COOM GREEN ENERGY PARK

FURTHER INFORMATION RESPONSE REPORT

Prepared for: Coom Green Energy Park Limited

Abstract: This document contains the response to a further information request issued by An Bord Pleanála for the proposed Coom Green Energy Park, (ABP ref. 308885). This report has been prepared by Fehily Timoney and Company (FT) on behalf of Coom Green Energy Limited.

Figure 1-1: Extract from Figure 11-2 showing additional residential receptor.

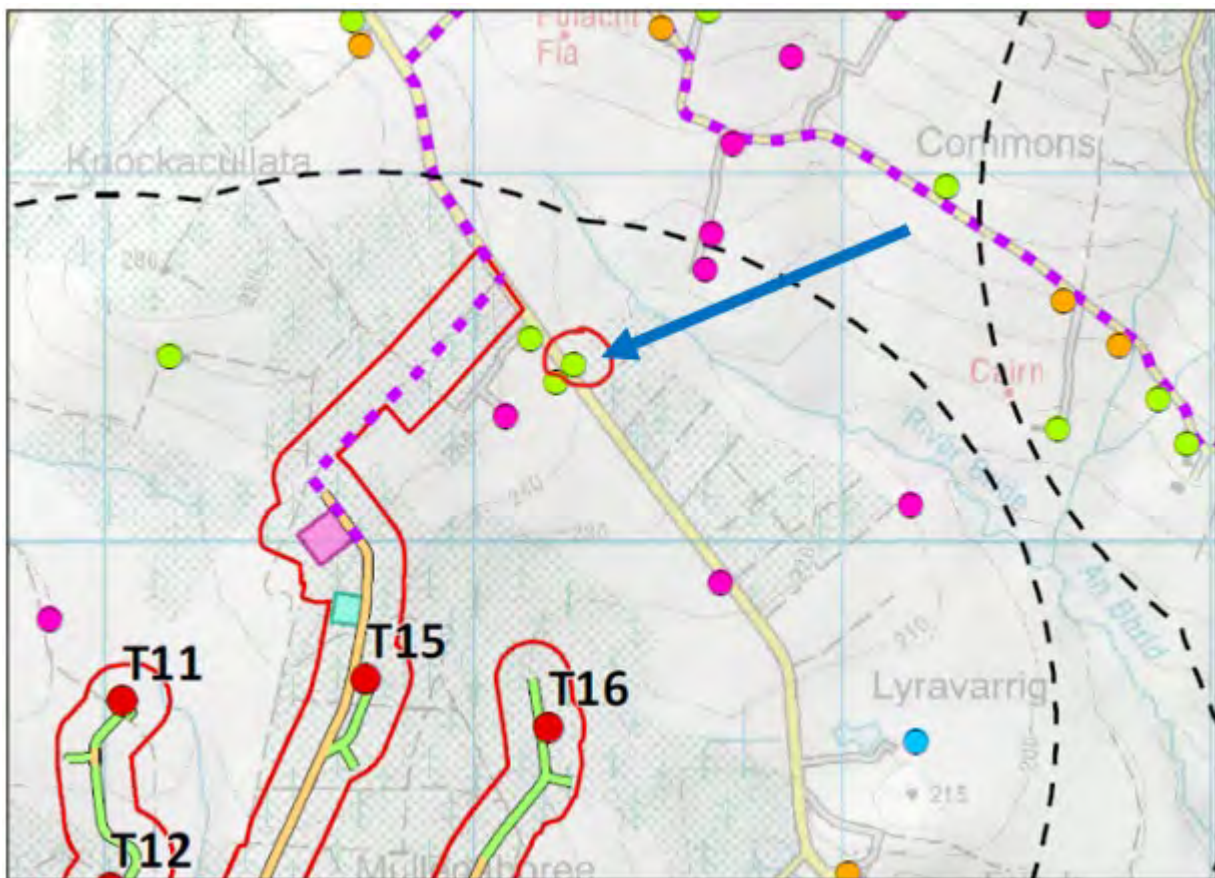
- (a) Figure 11-2 presented in the EIAR is stated to detail the receptors within the vicinity of the proposed development. Section 11.3.1 of the EIAR states that there are 2 planning consents within 1.38km of the turbines, however these are not shown.*
- (b) Furthermore, it is not clear whether the properties, residential or commercial or both of those landowners within whose property the turbines are proposed are included on Figure 11-2. Please address these matters.*
- (c) A number of submissions suggest that there are more than 115 receptors within the study area identified in Figure 12.1. Please respond to this matter.*
- (d) It is also stated that the 20 buildings classed as uninhabited/derelict/otherwise insensitive to shadow flicker, which have not considered as part of assessment, have not been identified. Please respond to this matter.*

The updated house survey was conducted in order to ensure that the classification status of buildings within the designated study were still valid. The updated survey included a review of new planning applications. Receptors identified by the revised house survey are presented in Figure 1-1.

- 2 no. planning permissions for additional commercial units which are extensions to existing receptors which relate to agriculture (Planning Reg. Ref: 205802 and Planning Reg. Ref: 206854)
- 1 no. additional residential receptor (Planning Reg. Ref: 215559) has been identified within the designated buffer zone, as indicated by the arrow in Figure 1.1, below. This application was granted on 11/10/2021.

Figure 2-2: Plan of Silt Trap in Swale

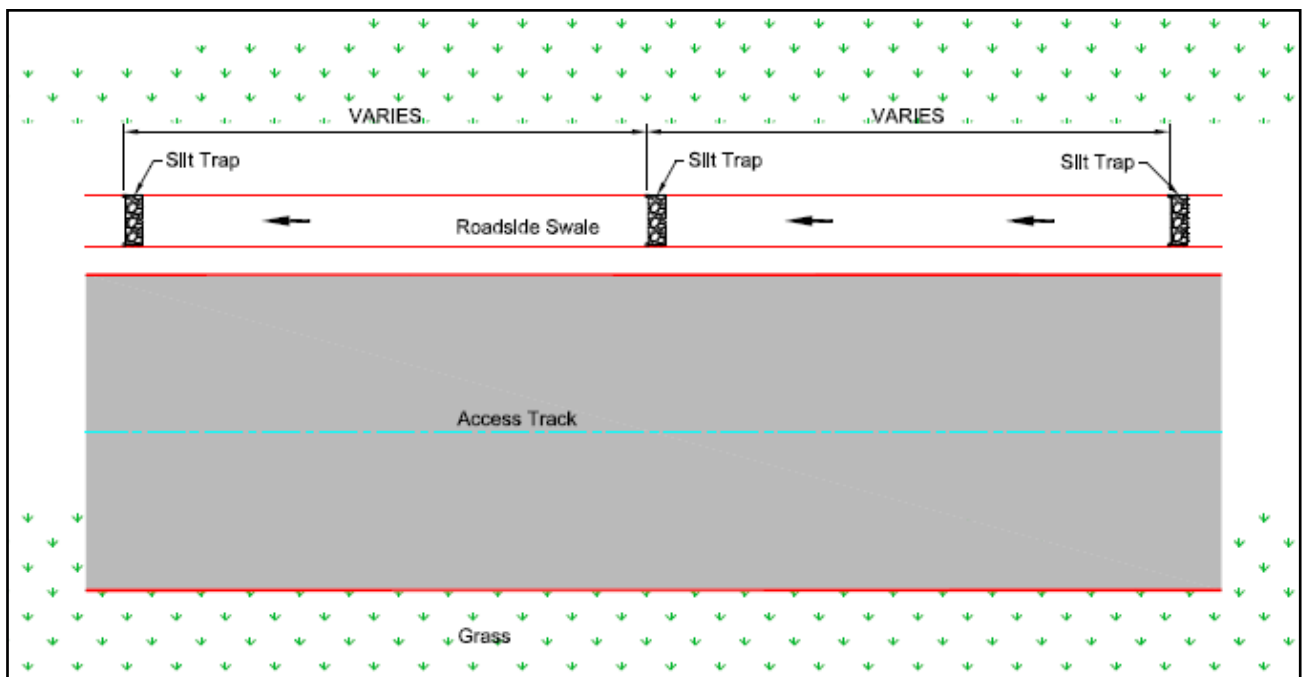
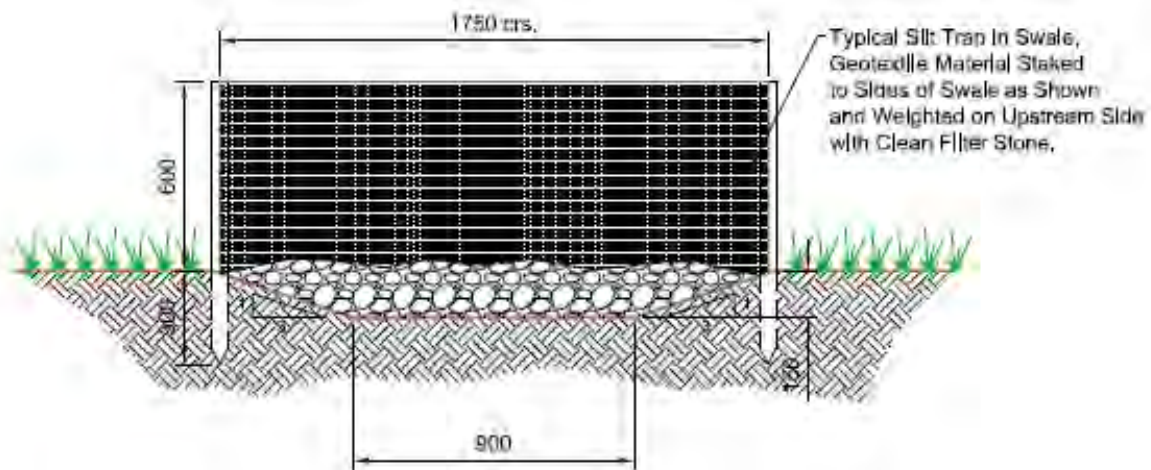
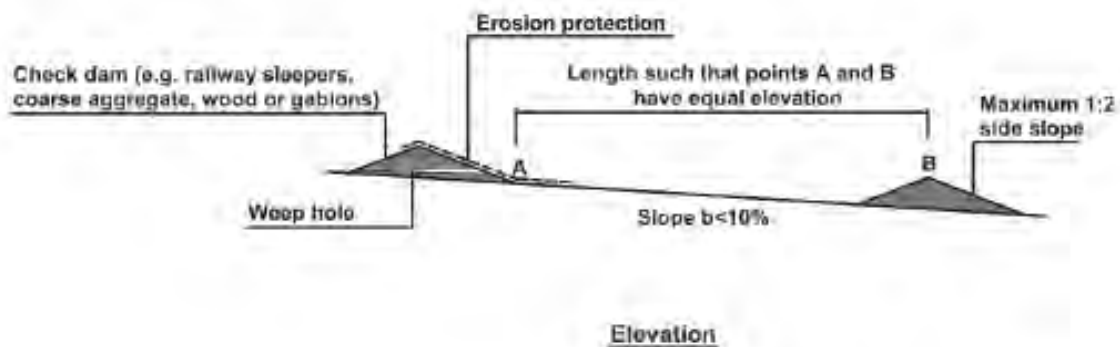
- (a) You are requested to clarify whether rock-structured, lined, sediment traps can be used along road drains for sediment control, and can there be a commitment to ensure that these are regularly cleaned out during the construction period prior to establishment of sufficient vegetation cover. If so, please provide an indicative map of the spacing of these traps, relative to drain slope.*

The EIAR and associated Surface Water Management Plan submitted with the EIAR describes sediment traps as follows: Both silt traps and check dams will be used to catch the sediments within the swales. The unsettled particles will run through a settlement pond and discharged diffusely. Silt traps will be provided in swales which will consist of geotextile staked across the swale at regular intervals. The geotextile will be weighed down on the upstream side with clean filter stone to provide further filtration and stability to the silt trap, as shown in Figure 4 to Figure 6 in the Surface Water Management Plan (SWMP). For ease of reference these figures have been shown below from Figure 2-1 to 2-3.

A plan of the silt trap locations is shown in Figure 2-2.

While the EIAR does not specify that the sediment traps will be rock lined, the applicant commits to ensuring that rock-lined, sediment traps will be used along road drains for sediment control, and commits to ensure that these are regularly cleaned out during the construction period prior to establishment of sufficient vegetation cover.

On slopes, silt traps will be placed at regular intervals between check dams. At slopes greater than 2%, check dams will be required in the swales and interceptor drains to slow down the velocities of flows and prevent erosion occurring, as shown in 2-4. These check dams will be in stone of minimum size 37.5 mm and will be laid at a spacing of between 9 and 30 m dependent on the slope.

Figure 7-5: HDD Profile

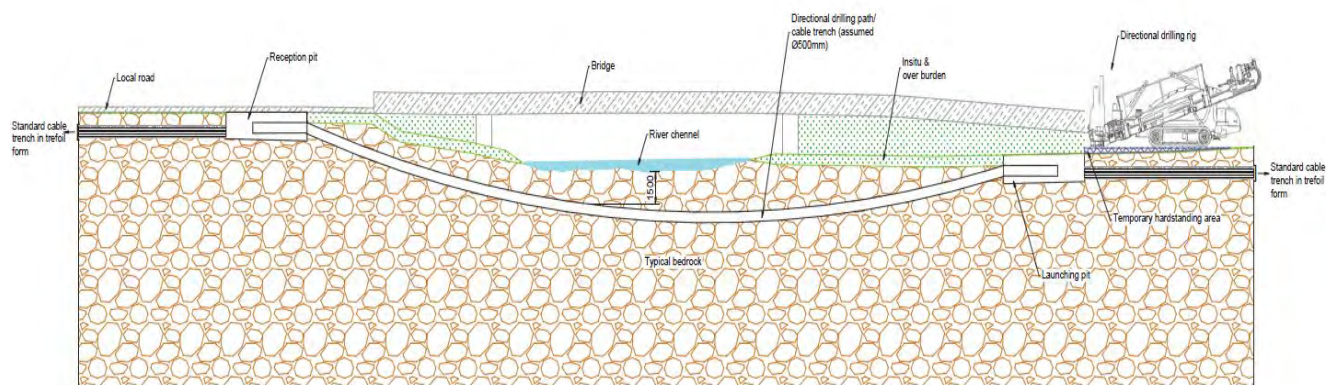
- (c) Section 3.5.8.1 of the EIAR refers to the proposed crossing of the M8 Motorway by way of horizontal directional drilling (HDD) and references Drawing P1306-2650-0033. However, no such drawing has been submitted. Furthermore, Drawing P1306-0501-0003 does not appear to have been submitted as part of the application drawings. Please address.

The drawing referred to by the Planning Authority above (Drawing Ref. P1306-2650-0033), illustrated the plan view of the grid connection route (GCR) as it passes under the M8 motorway via HDD east of Corrin Woods. The Grid Connection Route has been considered as part of the overall project within the EIAR and NIS and does not form part of the application for consent. A new revision of this drawing (Drawing Ref. P20-099-2650-0033) with further details of the proposed HDD has been prepared and included in Appendix 4 of this report.

The HDD path is illustrated on drawing Ref. P20-099-0300-0027 in Appendix 4. The drawing shows a plan and longitudinal section from the HDD entry point to exit point and indicates the bore alignment under the M8 motorway. As stated in the Further Information Request (c), a methodology for the HDD was included in the EIAR section 3.5.8.1 of Chapter 3 and in the CEMP section 3.4.1.14.
